Type Approval E20 44R 04 4013 – Braxx Smart Kid Belt

Submitted by the expert from the Netherlands

Guide strap approved as Child Restraint System under the provisions of ECE R44.04 supplement 11.

Picture 5; snap shot from UN Reg. 44

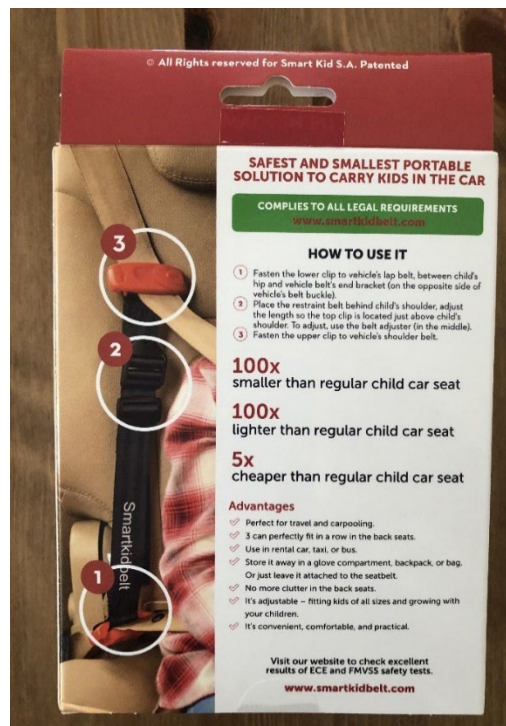
Position NL: The product does NOT comply, the required label and wording are not present in the packing, and the information that is given instead is not in the language of the country where the device is sold.
